Access Compliance Report

Public Rights-of-Way

(Curb Ramps)

Intersection ID: 11659	Main Street: E_16TH_ST	Cross Street: N_DAVIDSON_ST	Location: N
ADA ID: E54C552EC0C7	Ramp Type: PerpDiag	Initial Pass/Fail: Fail	Overall Compliance: No
Severity Score: 8.75			
Codes/Mitigation Info/Possible Solution		Field Measurements/Component Compliance

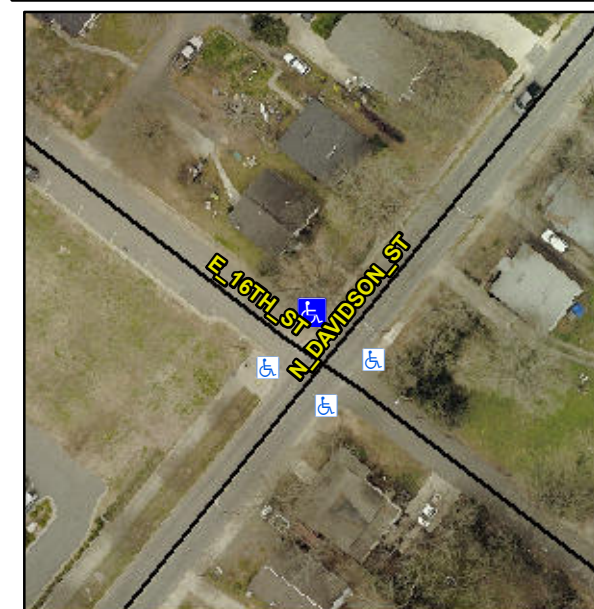
Not Found, R304.5.1

Compliance	Description	Data	Compliance	Description	Data
N/A	Ramp Length (in)	60.0	Yes	Ramp Slope (%)	5.3
No	Ramp Width (in)	42.0	Yes	Ramp XSlope (%)	0.7
N/A	Flare Type LT	N/A	N/A	Flare Type RT	N/A
N/A	Flare Slope LT (%)	N/A	N/A	Flare Slope RT (%)	N/A
N/A	Flare Traversable LT?	N/A	N/A	Flare Traversable RT?	N/A
N/A	Landing Length (in)	N/A	N/A	DWS Provided?	N/A
N/A	Landing Width (in)	N/A	N/A	DWS Contrast?	N/A
N/A	Landing Slope (%)	N/A	N/A	DWS Length (in)	N/A
N/A	Landing X Slope (%)	N/A	N/A	DWS Full Width?	N/A
N/A	Landing Curb? (Y/N)	N/A	N/A	DWS Offset (in)	N/A
N/A	Shared Landing?	N/A			
N/A	Gutter Ponding?	Yes	N/A	Gutter Slope (%)	N/A
N/A	Gutter Lip Ht (in)	N/A	N/A	Gutter X Slope (%)	N/A
N/A	Painted X Walk1?	No	N/A	Painted X Walk2?	No
	X Walk 1 Direction	To SW		X Walk 2 Direction	To SE
N/A	X Walk 1 Width (in)	N/A	N/A	X Walk 2 Width (in)	N/A
	X Walk 1 Slope (%)	0.8		X Walk 2 Slope (%)	3.2
	X Walk 1 X Slope (%)	1.4		X Walk 2 X Slope (%)	1.4

Remove & Replace Curb Ramp With Two New Directional Ramps or Equivalent.
